# ADDENDUM NO. 1

**PROJECT NO:** STPSU-0220(256)  
**PROJECT DESCRIPTION:** INSTALLATION OF A ROUNDABOUT AT NORTH SECTION STREET/SCENIC 98 (VETERANS DR)/MAIN STREET  
**PROJECT OWNER:** CITY OF FAIRHOPE  
**OWNER REP / ENGINEER:** VOLKERT INC. / JORDAN STRINGFELLOW, P.E.  
**DATE OF ISSUE:** November 15, 2024  
**RECIPIENT:** Meeting Attendees and Plan Holders

STPSU PROJECT ROUNDABOUT INSTALLATION

**REVISED PLAN SHEETS**  
**NOVEMBER 15, 2024**

| STPSU-0220(256)      | 2024        | 65       |

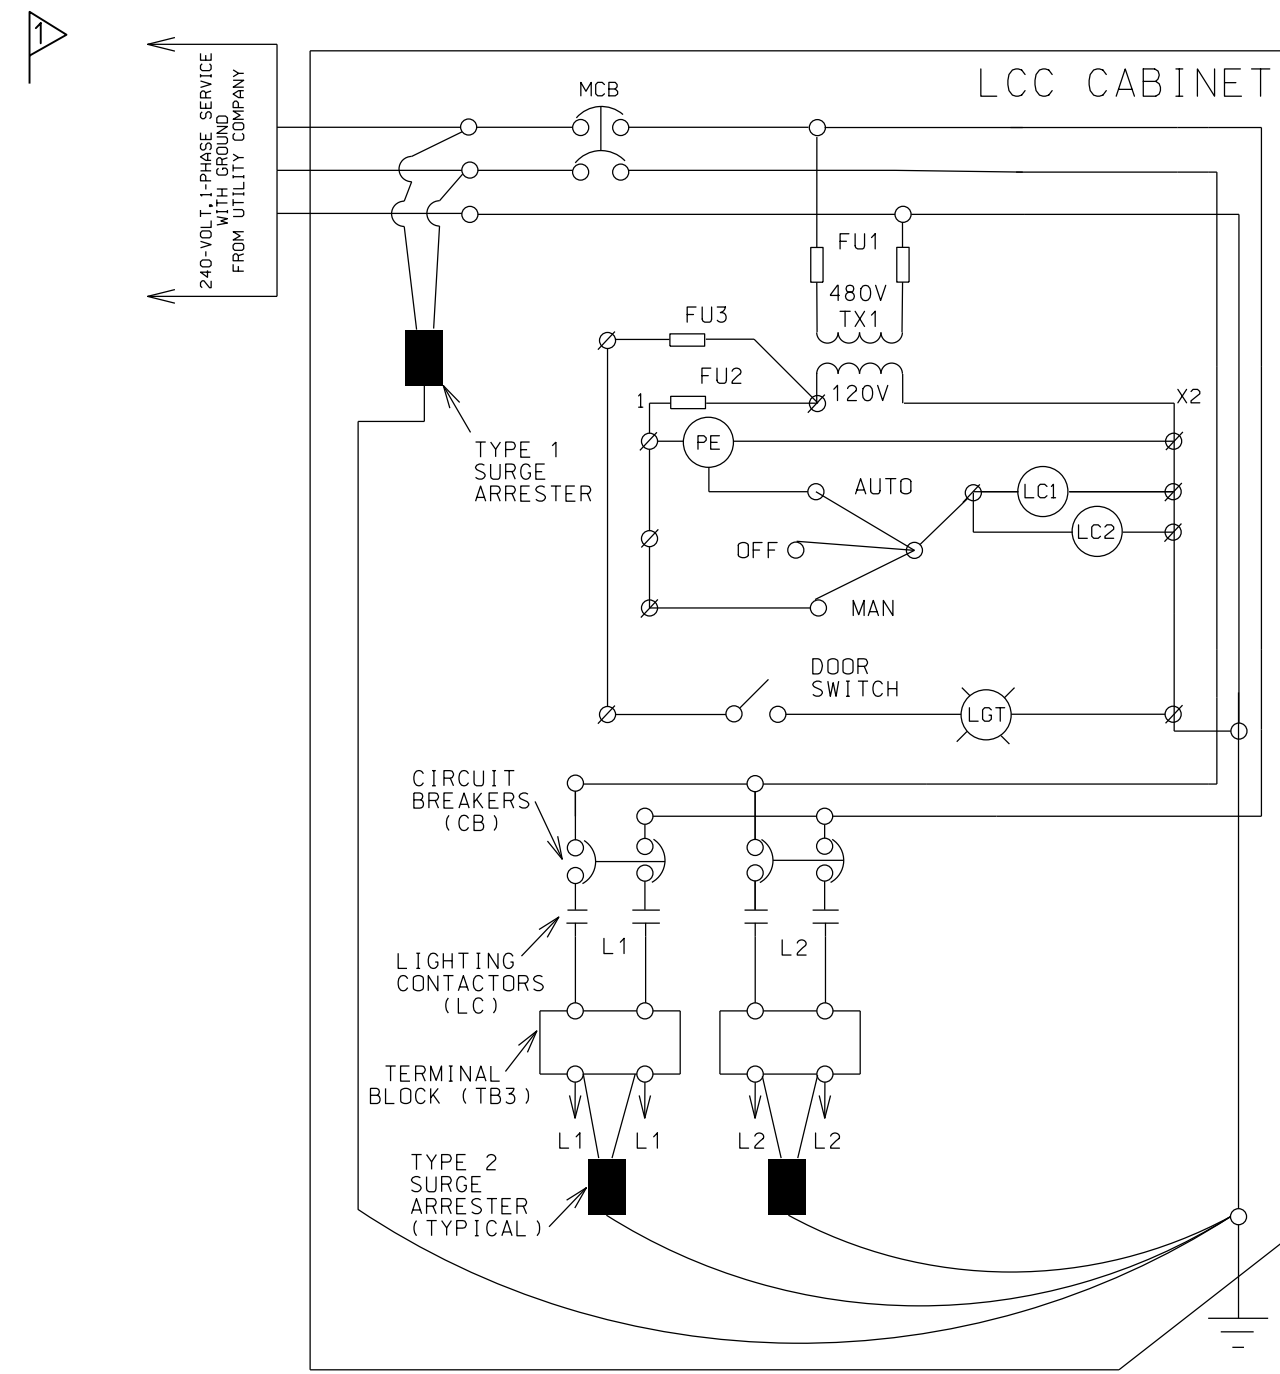
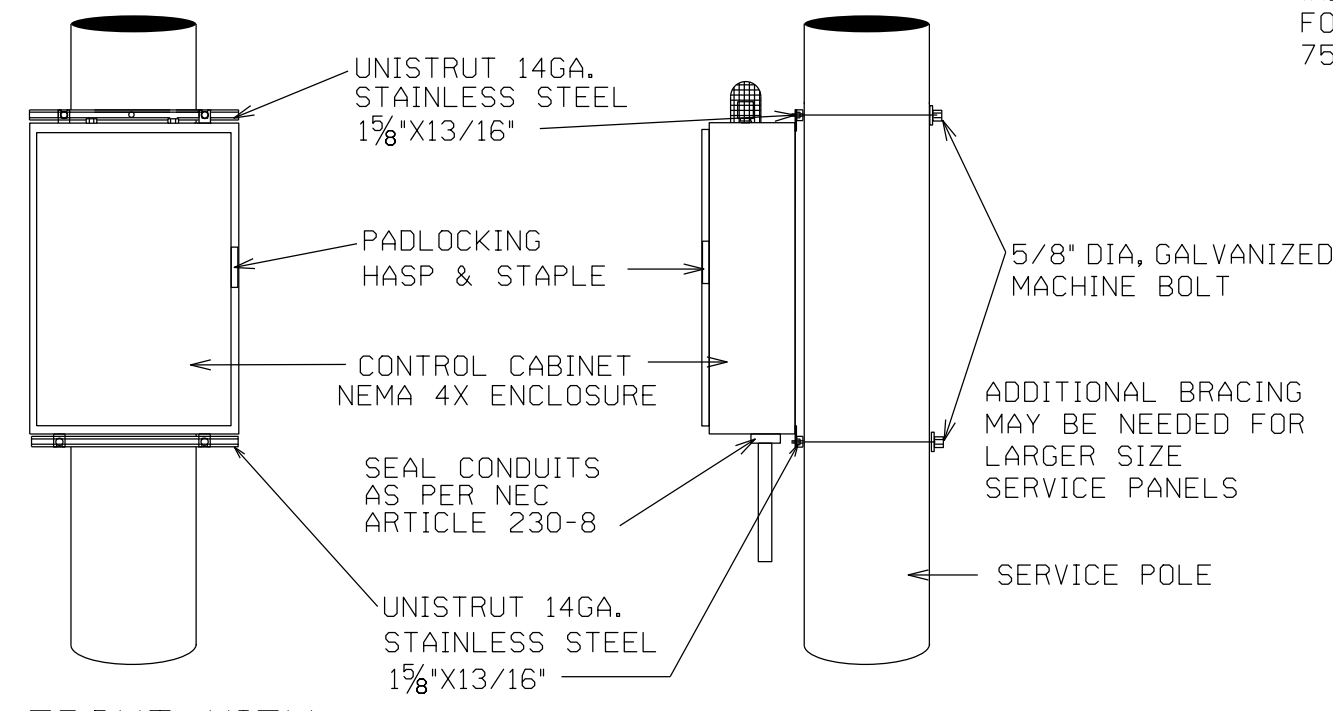
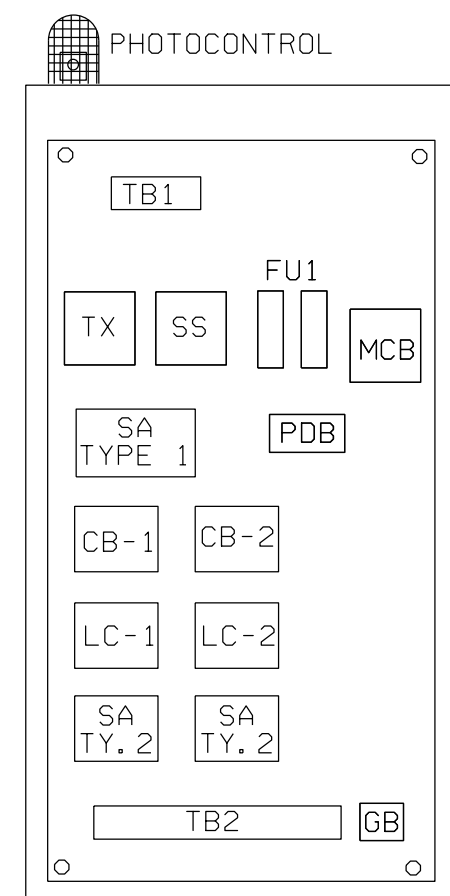
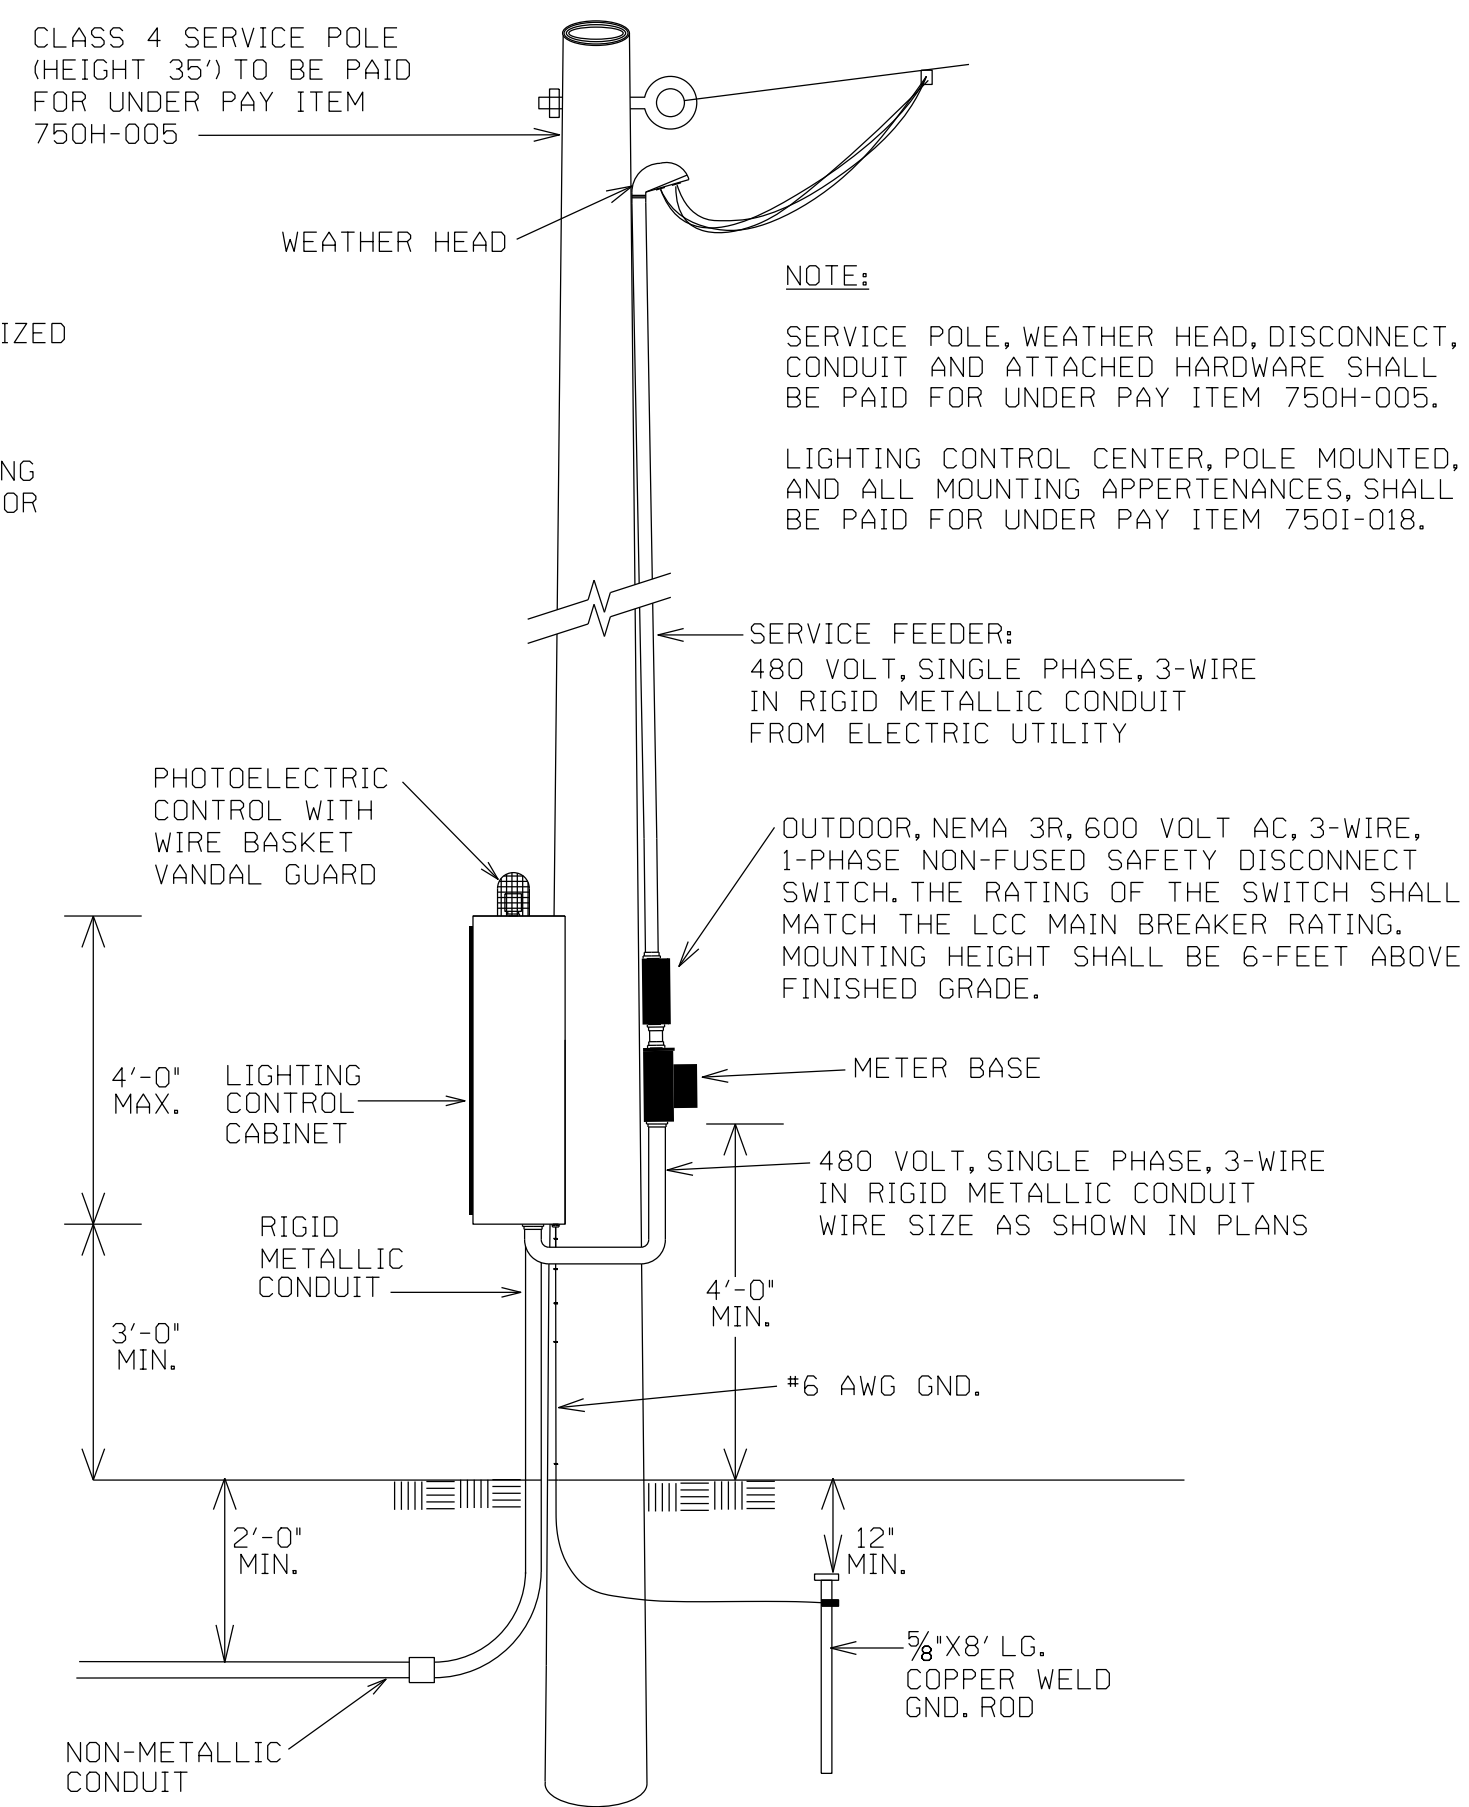
12. Is lighting control center A pole or pad mounted?

**ANSWER:** Lighting control center is intended to be pole mounted per the pay item description. A pole mounted detail has been implemented into the plans (see sheet #65 attached). This additional sheet will be considered as part of the issued for bid set of plans. If the option for pad mounted is more economical, this could be approved through the submittal review process. See 2024 ALDOT Standard Drawing number RLD-002 for details on pad-mounted control center.

REV 1:  
ADDED SHEET 65 -  
SPECIAL PROJECT DETAIL  
POLE MOUNTED CONTROL  
CENTER
